REFERRAL REPORT

TO: Vancouver City Council

FROM: General Manager of Planning, Urban Design and Sustainability

SUBJECT: CD-1 Rezoning: 1325 West 70th Avenue

Figure 3: Ground floor plan

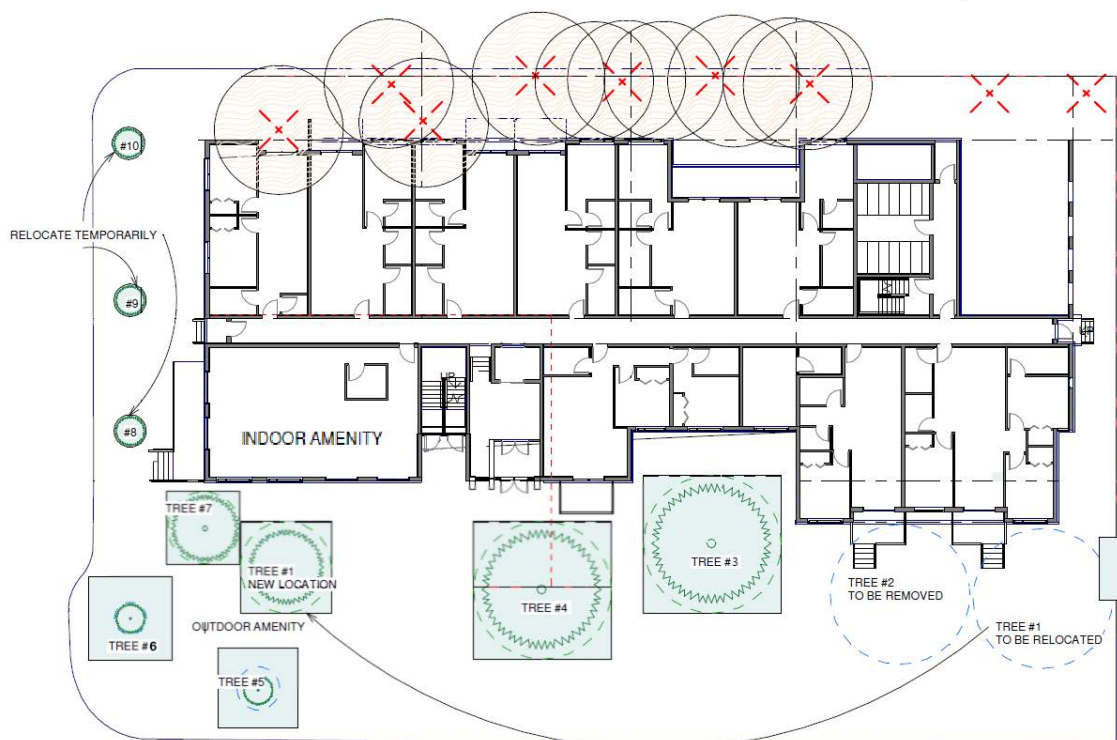
- 1.4 Design development to provide a more prominent architectural expression for the main residential entry and create a privacy buffer for Unit 109.
- 1.5 Design development to maintain high quality exterior cladding material, such as proposed brick, at subsequent phases of development.
- 1.6 Identification on the architectural drawings of any built features intended to create a bird-friendly design.

Shadow Study

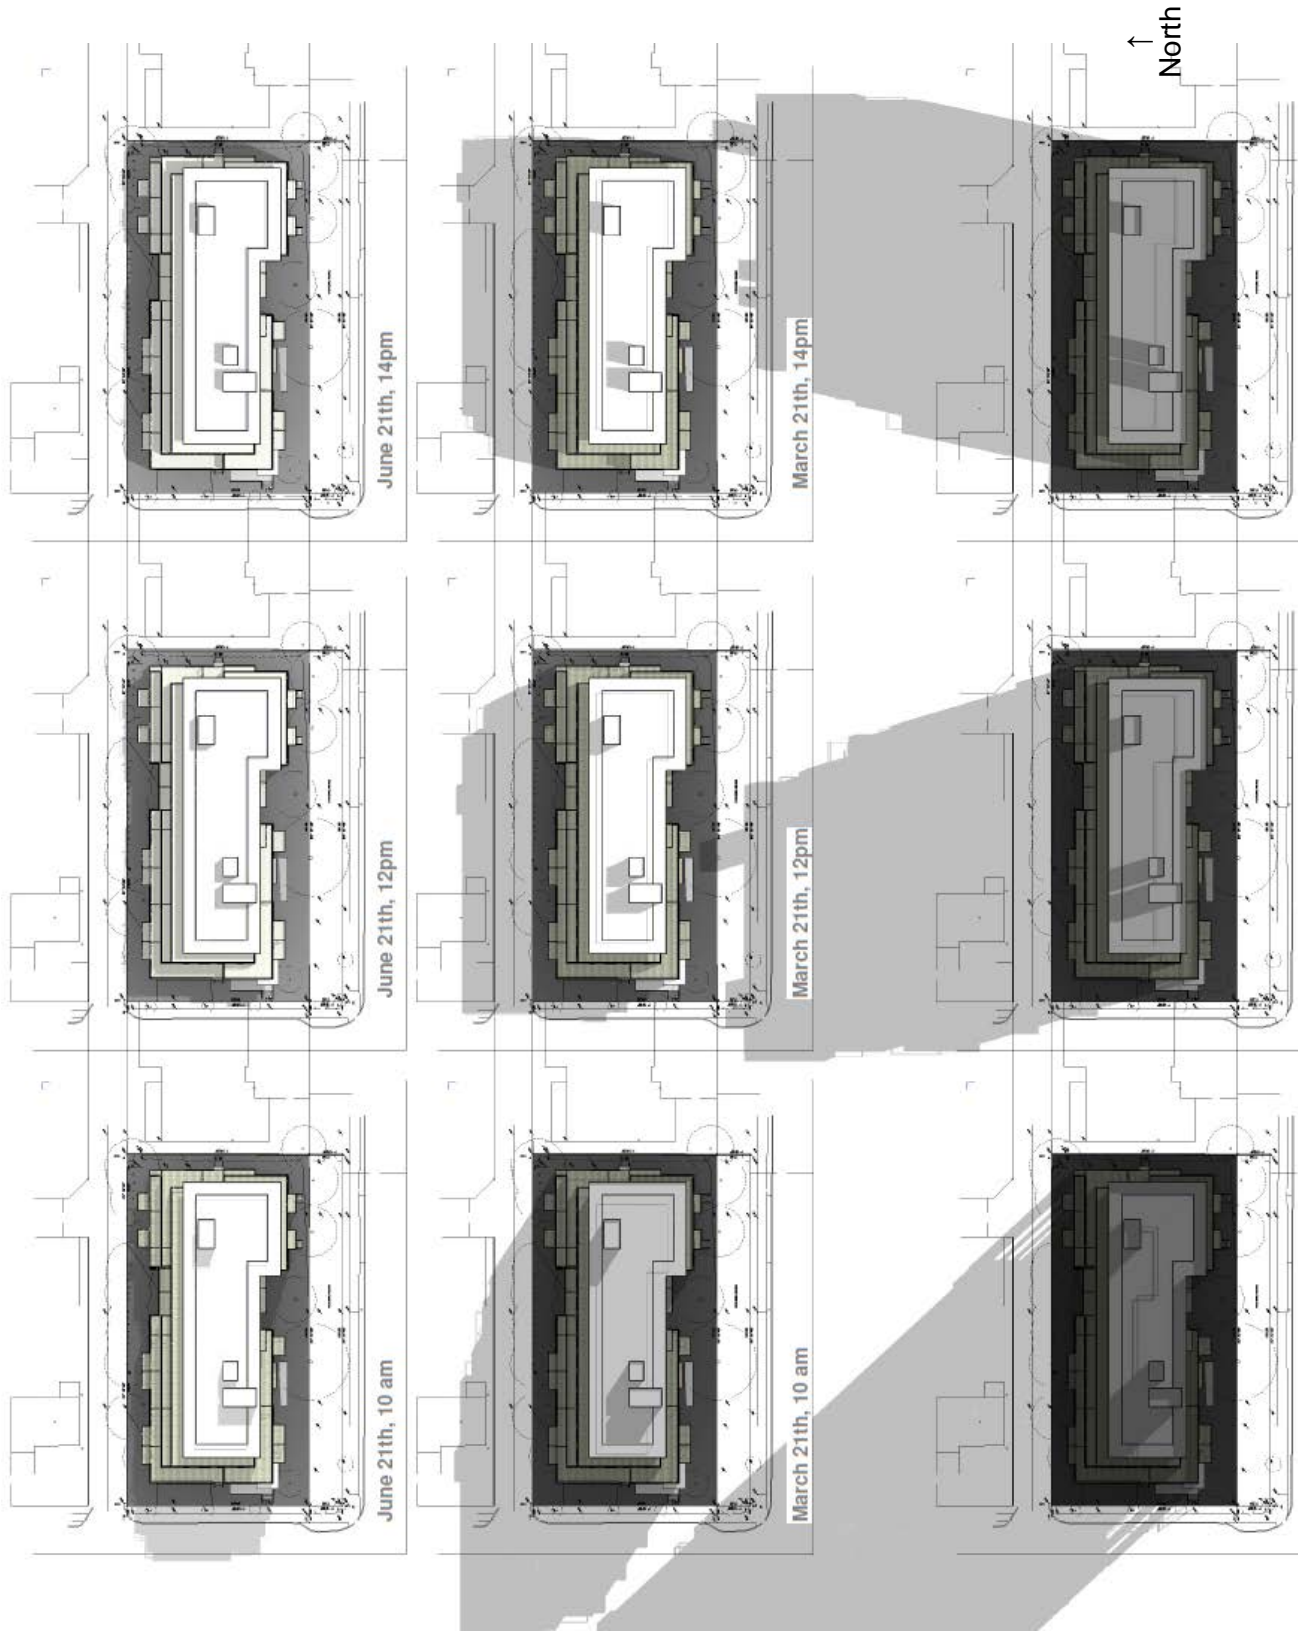
Staff Response – In response to concerns, staff requested and reviewed further shadow studies by the applicant (as shown in Appendix D). A design development condition has been added to reduce shadowing impact on the properties to the north. Street, lane, and other public realm upgrades, which will address parking and traffic concerns, form a part of the Engineering conditions set out in Appendix B.

- 1.1 Design development to provide additional setbacks at the rear to further reduce scale and mitigate shadow impacts on residential properties to the north.
